**Display**

Subject: **WHITE BALANCE ERROR WHEN USING  
 BKM-1450/2056 BOARD**

Model: **BVM-1311/1316/1316C/1911/1916/2811**

**Figure 1**

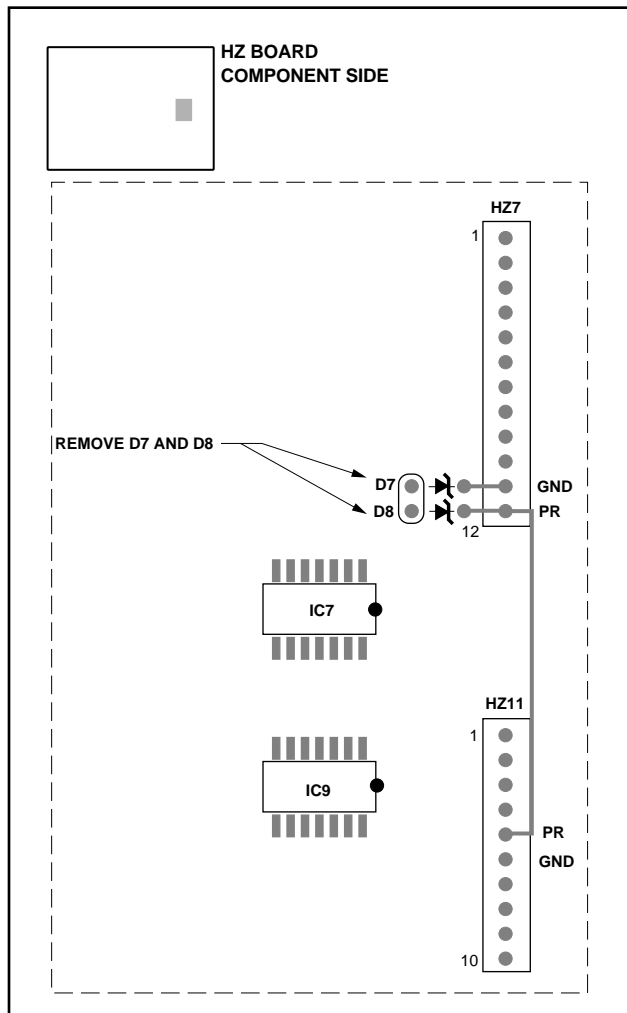
If a BKM-1450/2056 auto-setup board is used, an adjustment error may occur when adjusting the white balance, especially of a 13-inch monitor.

To correct this condition, remove D7 and D8 (RD5.6SB) from the HZ board as shown in Figures 1 and 2.
